Reference: 2265 Laurel Lane - CPD Amendment
DCI2024-00019 (1st Resubmittal)

We are in receipt of your review letter dated June 11, 2024 for the above referenced project. The following items are submitted for your continued review per this request for additional information:

2265 Laurel Lane – CPD Amendment

MASTER CONCEPT PLAN

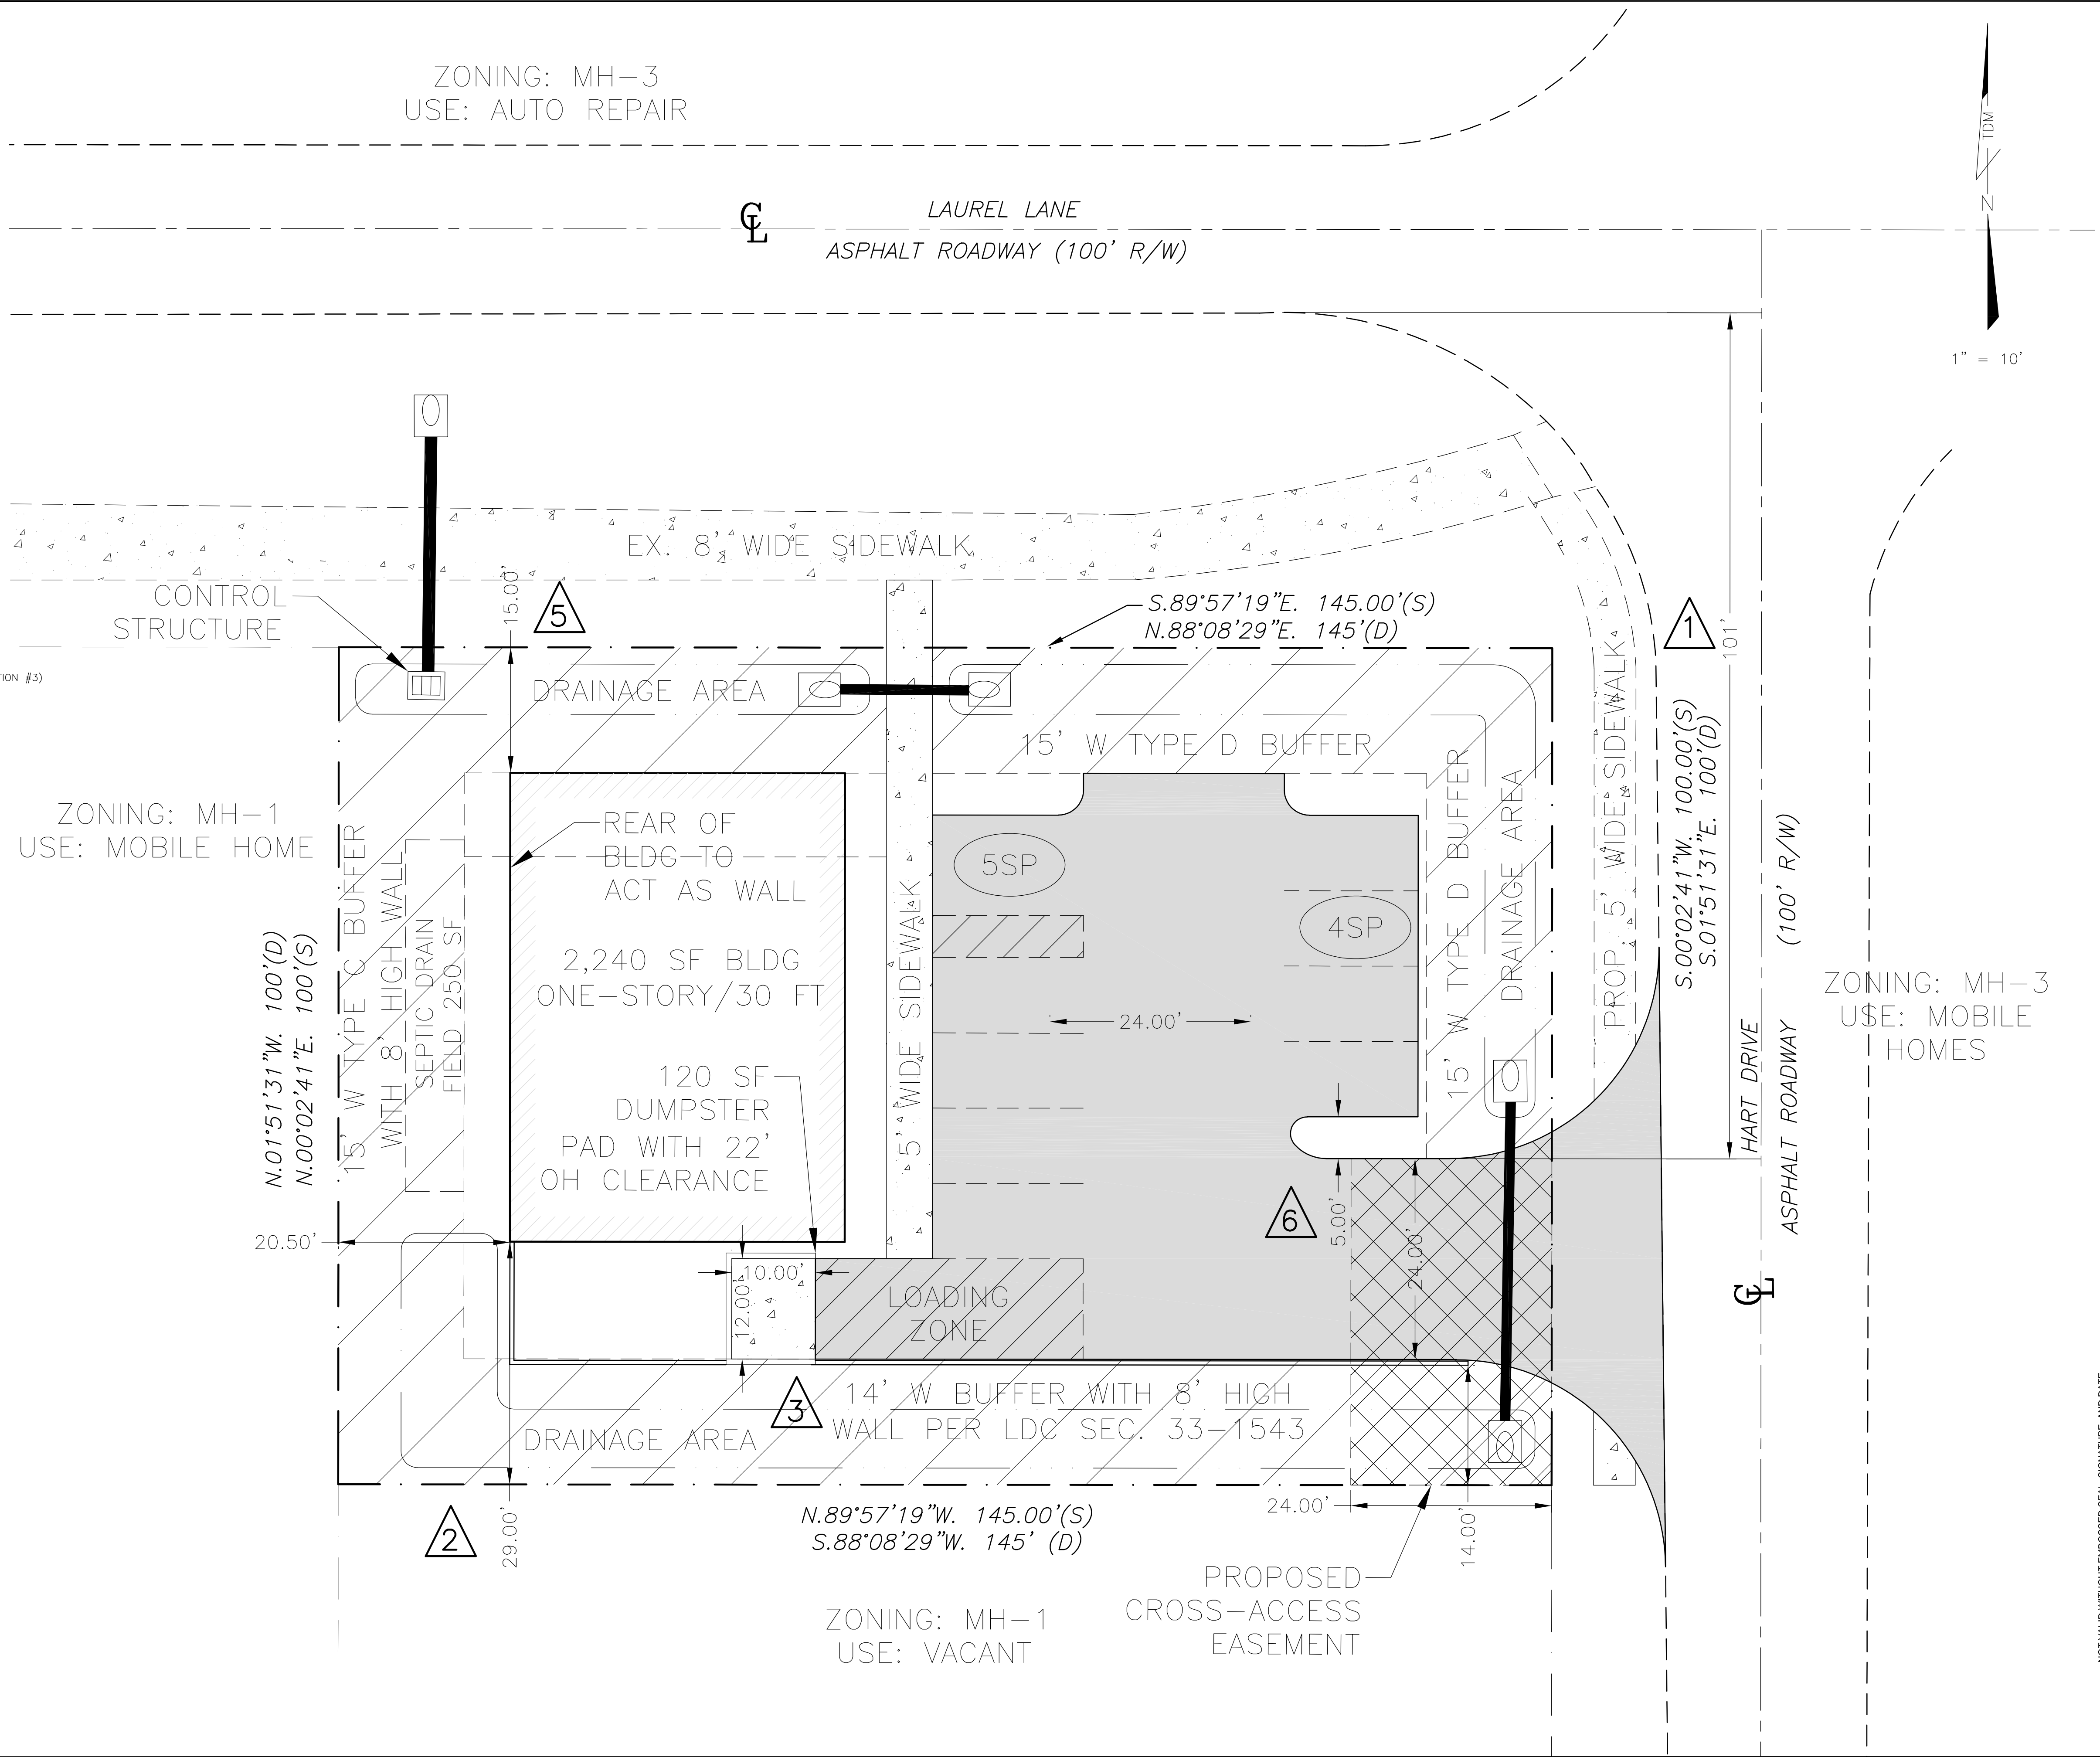
6. The narrative states the connection separation distance is 105', and the MCP states 105'9". Please provide consistency on the exact measurement.

15. Provide cross-access easement for the property to the south as per Lee Plan Policy 12.3.5 and LDC 10-285 and show that in the MCP.

16. Provide the turning/swept paths for anticipated trucks to demonstrate the site plan with the proposed 20-ft wide driveway will have sufficient width and length for all critical vehicular queuing, stacking, maneuvering, standing, and parking for the expected future traffic to be carried out completely beyond the Hart Dr ROW.

17. Provide cross sections for the west and south property lines depicting the width and depth of the drainage area, 15-foot-wide buffer, location of eight-foot wall, and the buffer planting area between the property line and the wall.

18. Demonstrate how the landscape material per LDC Section 33-1543(c & d) will survive within a ten-foot-wide planting area as the Lee Plan analysis indicates. Buffers are required to be proposed between the property line and wall per LDC Section 10-421(a)(8). Staff has concerns about survivability because the enhanced landscape material required per LDC Section 33-1543(c & d).

19. An additional deviation may be needed to allow the landscape material to be located on either side of the wall. Provide more detail of how the alternative buffer to the code will provide screening for compatibility including how the depth of the drainage swale will affect the screening.

Response: Please see the revised MCP and Schedule of Deviations for the correction as requested.

Response: Please see the revised MCP for the proposed cross-access easement for the subject property as requested.

Response: Please see the attached, revised MCP and Schedule of Deviations. The proposed driveway is 24 feet as required by the LDC and the deviation has been withdrawn.

Response: Please see the attached, revised MCP and Schedule of Deviations. Since only the lot to the south meets the definition of an existing large residential lot (greater than 14,520 sf), the buffer to the west is a standard 15-foot wide Type C buffer with an 8' high solid opaque wall per LDC Sec. 10-416(d). The MCP provides a 14' wide buffer to the south with an 8' high solid opaque wall with buffer vegetation as required by LDC Sec. 33-1543. The buffer wall is set 14 feet from the south property line, which provides sufficient space for the enhanced vegetation plus a narrow drainage swale.

Response: Please see the attached, revised MCP and Schedule of Deviations. Only the lot to the south meets the definition of an existing large residential lot (greater than 14,520 sf). The MCP provides a 14' wide buffer to the south with an 8' high solid opaque wall with enhanced buffer vegetation as required by LDC Sec. 33-1543(c and d). The buffer wall is set 14 feet from the south property line, which provides sufficient space for the enhanced vegetation plus a narrow drainage swale.

Response: Please see the revised MCP and Schedule of Deviations. The proposed buffer wall is set 14 feet from the south property line, which provides sufficient space for the enhanced vegetation plus a narrow drainage swale.

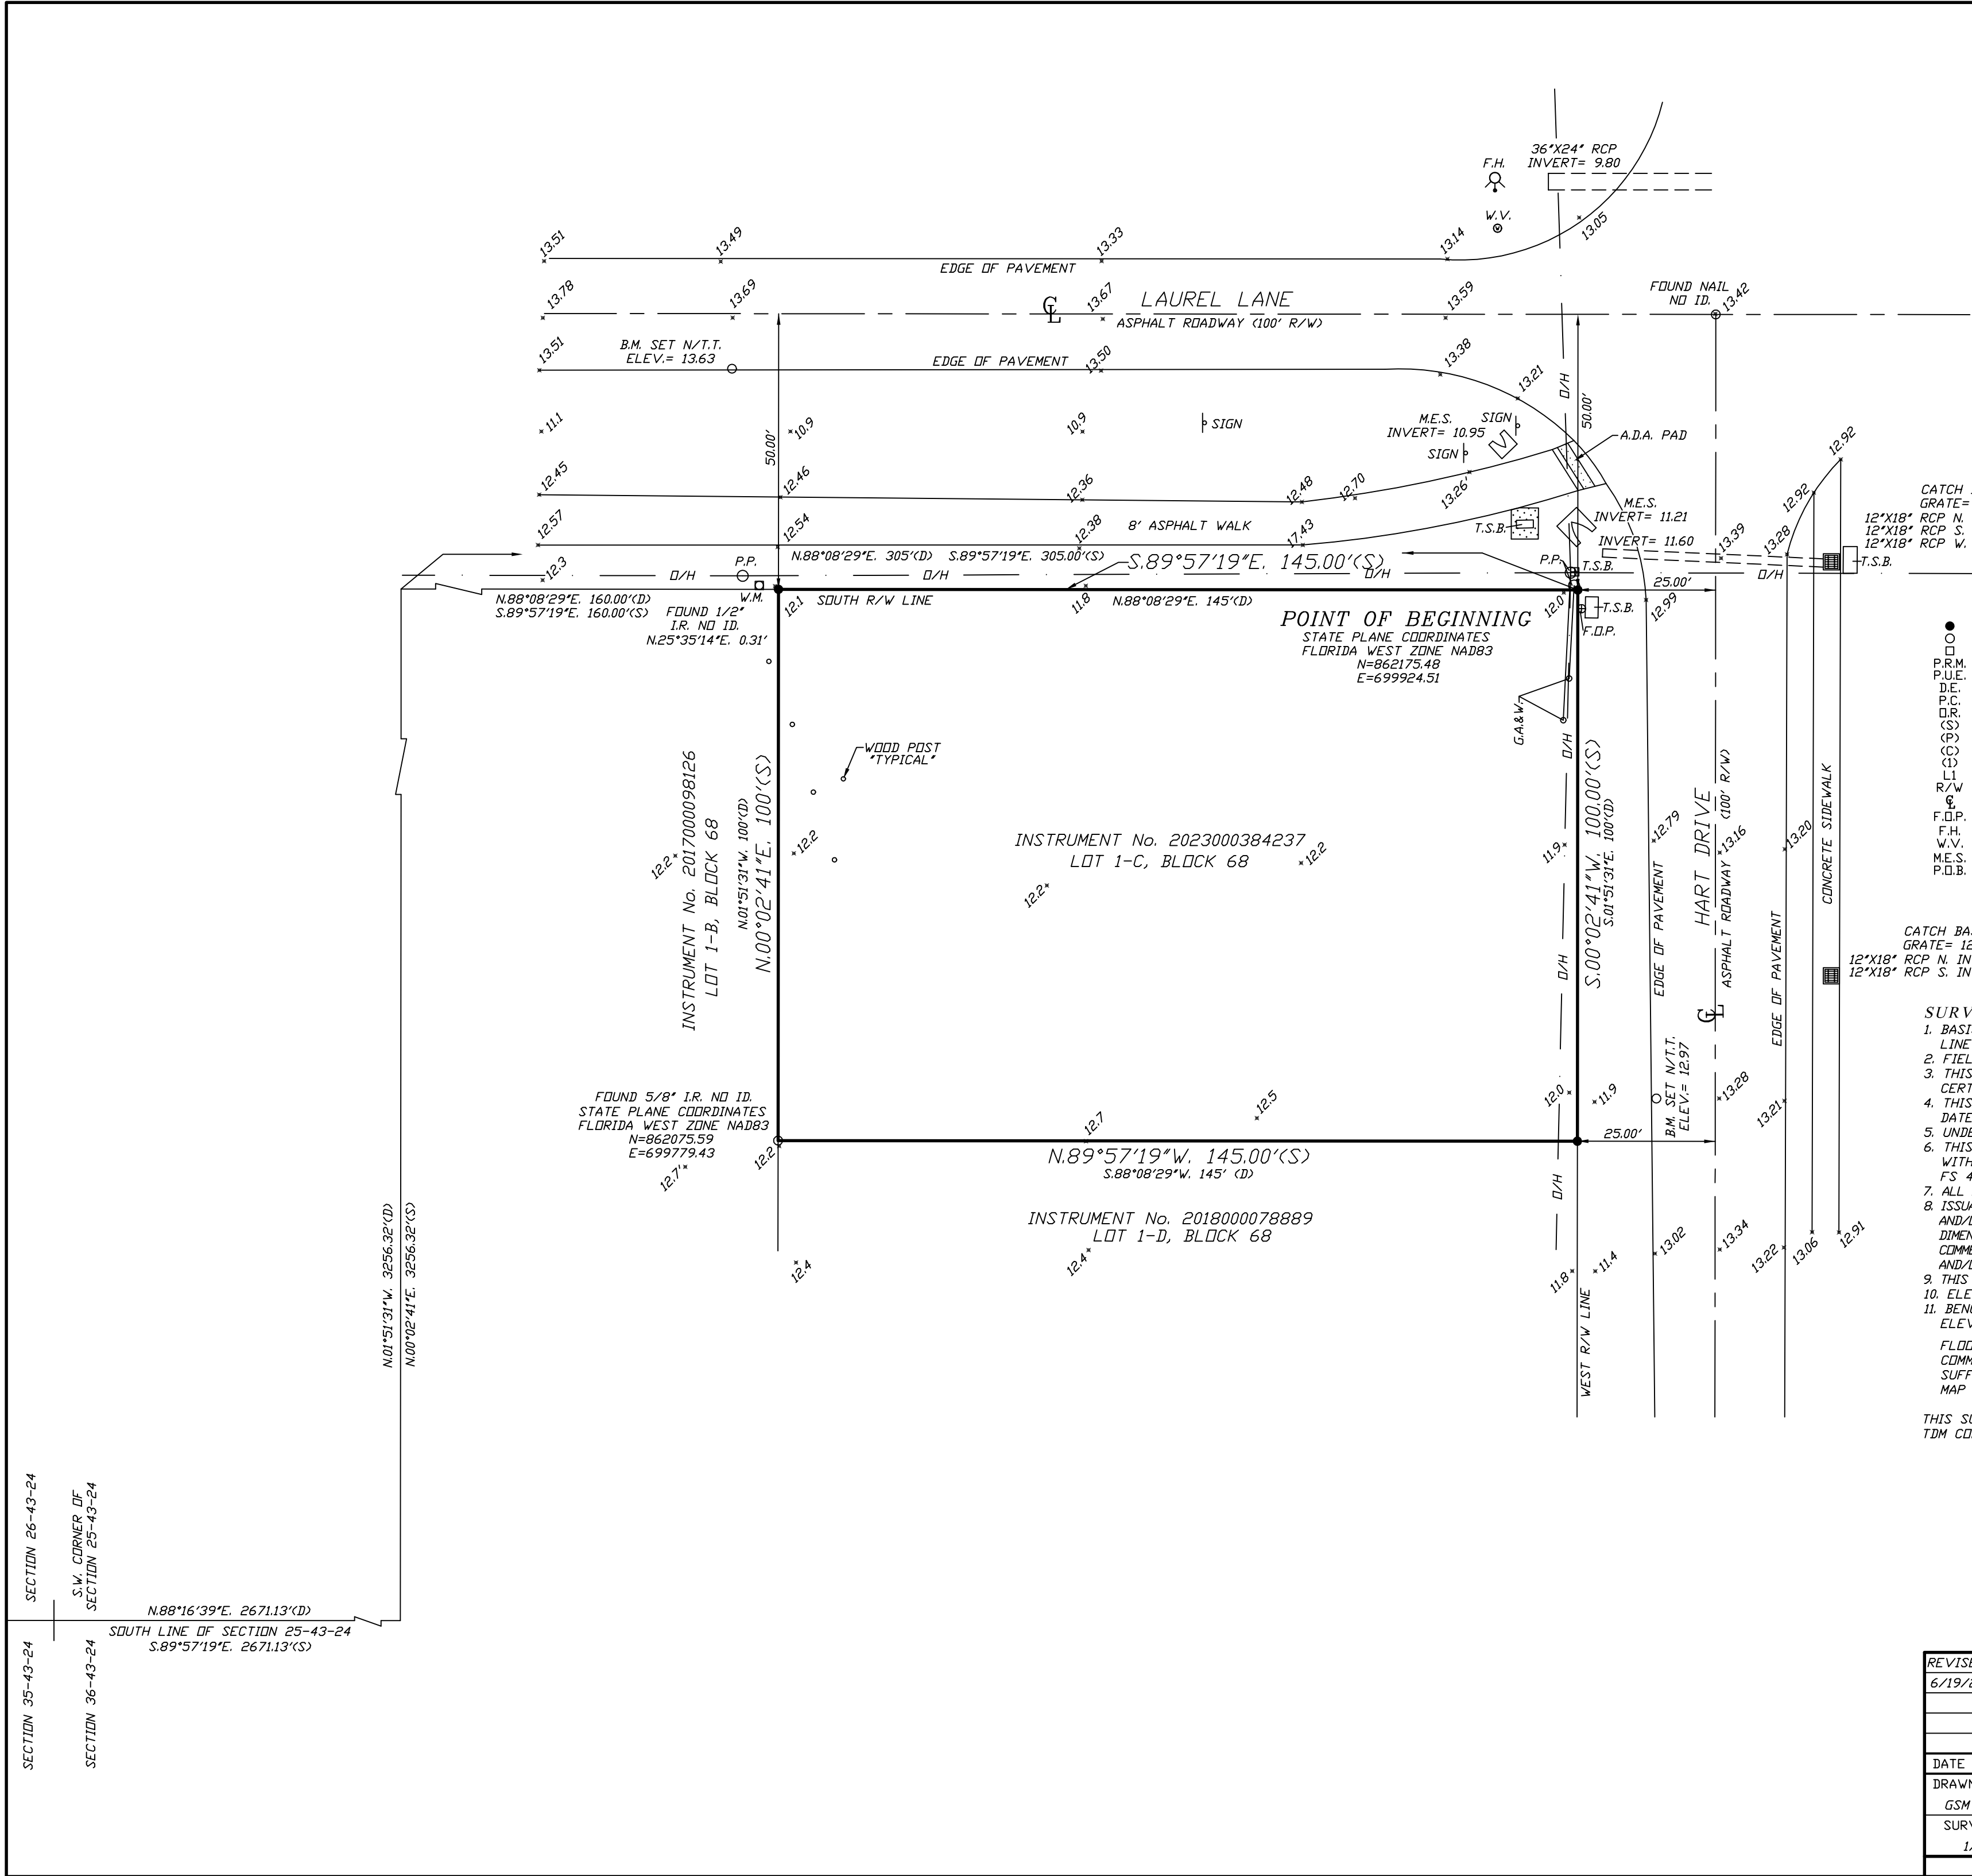
7. Please provide a boundary survey in accordance with the requirements of Lee County LDC §34-202(a)(6).
 - The survey must be tied to the state plane coordinate system for the Florida West Zone (the most current adjustment is required) with two coordinates, one coordinate being the point of beginning (POB) and the other an opposing corner.
 - The boundary survey labels section 36-43-24 as section 25-43-24.

Response: Please see the revised Boundary Survey for the corrections as requested.
